Aspirational Path Report for A002 Taynuilt to Tyndrum

Argyll and Bute Council Core Path Plan Finalised Draft 2012 Minute of Discussions by the Access Forum

Path Number: A002

Path Name: Taynuilt - Tyndrum

Proposed amendment (i) A002; purple and green line shows proposed new alignment of A002 at this location; red and black line shows where this section of A002 was previously drawn and is to be deleted.

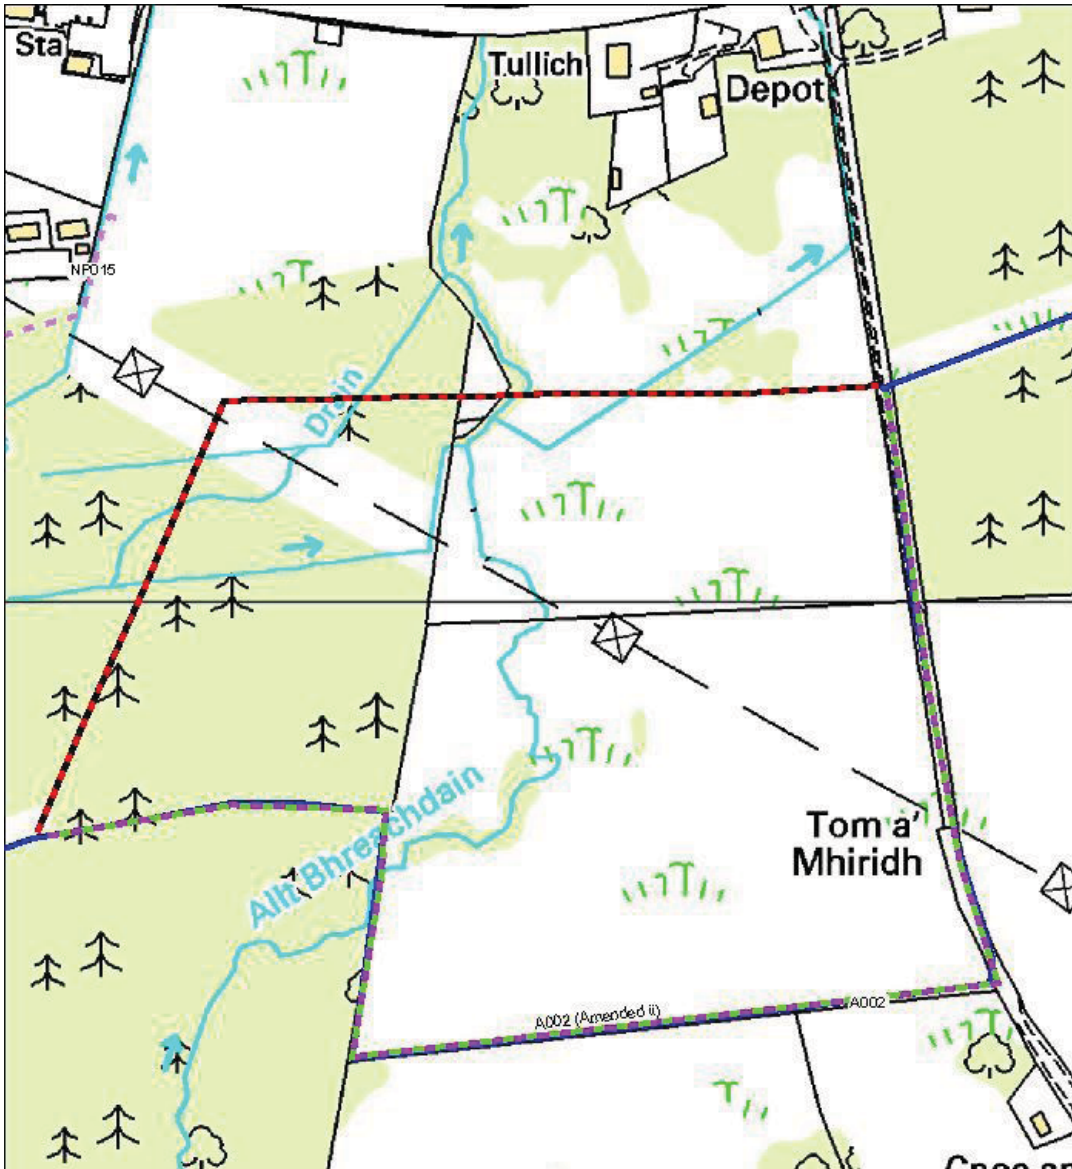
- i) **Houses Loch Awe Village** - Path next to houses Davar, Mo Dairach and the Sheiling should be moved higher up the hill.
- ii) **Houses at Tullich** - The section of path at Tullich and Anne Lea is too close to these properties
- iii) **Kilchurn Castle to Loch Awe** - The section between Loch Awe hotel and Kilchurn Castle should be a core path
- iv) **Forestry** - There is concern that core path status will affect the ability of the forestry manager to close the route for health and safety reason. There is also concern that the Council will request that the route be reinstated after operational works, and this could place an additional financial burden on the land owner

i) Houses Loch Awe Village

The proposed route of the path close to the houses Davar, Mo Dairach and the Sheiling has been redrawn higher up the hill although the final line of the route would be decided following further public consultation.

iii) Kilchurn Castle to Loch Awe

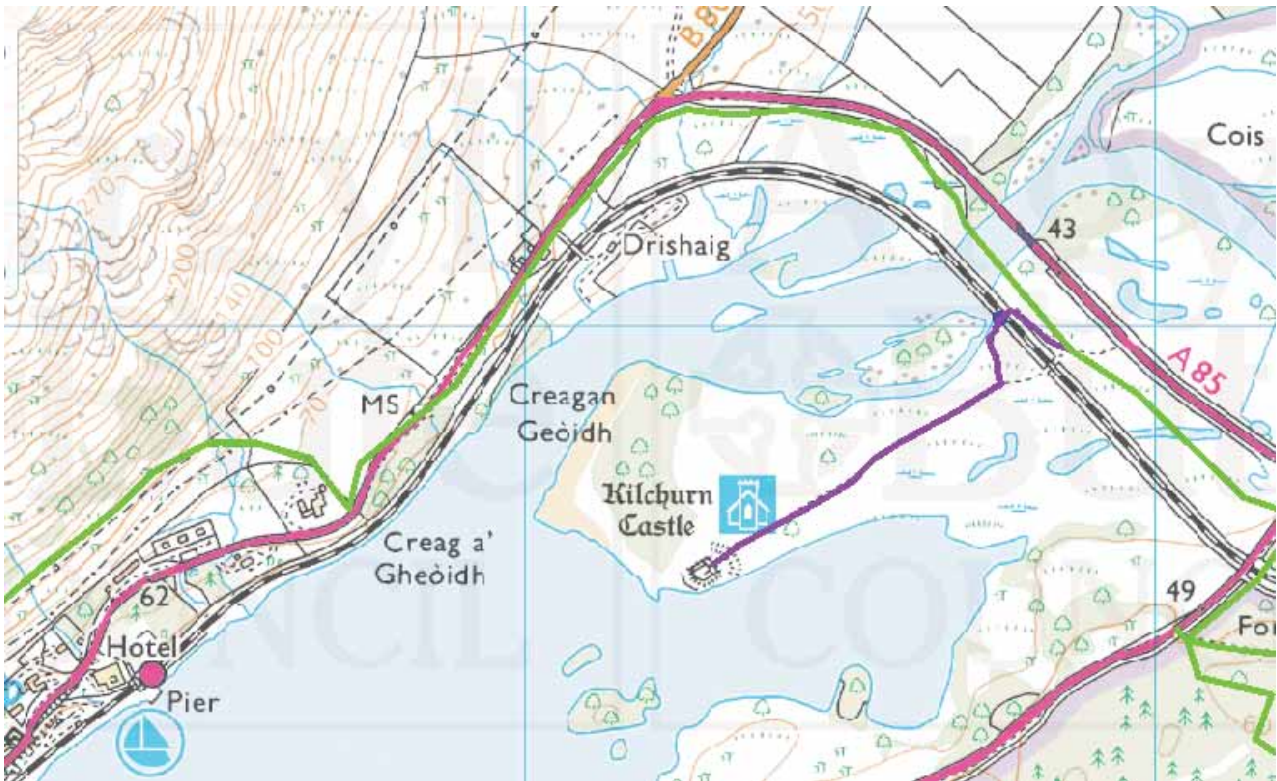
The section between Loch Awe hotel and Kilchurn Castle should be a core path

The footway beside the road is narrow, is not continuous along the whole length of this section of road and because this is a main A Road linking Oban with Tyndrum and designating it as a Core Path would not be appropriate. Creating a path on the approaches to the bridge where crash barriers have been installed would be both complex and costly because of the need to ensure that the barriers continued to provide motorists with protection. There is no footway between the bridge over the River Orchy and the junction with the B8077 and users would have to resort to the rough mown road verge. Even with the provision of a path over this distance it would be unlikely to attract many recreational users wishing to visit the castle because it would not be a pleasant experience.

However if further consultation with the community demonstrates that the community wishes to create a path between Loch Awe hotel and Kilchurn Castle then this section of path should be prioritised for development. This is likely to require a new bridge to the west of the road bridge which would require a substantial capital investment. It is also likely that Transport Scotland as the Trunk Road Authority and Network Rail would need to be consulted on any proposed solution because it could impact on their interests. However this link might be justified particularly if it allowed users to continue to Dalmally a distance of around three miles linking the communities for walkers and cyclists.
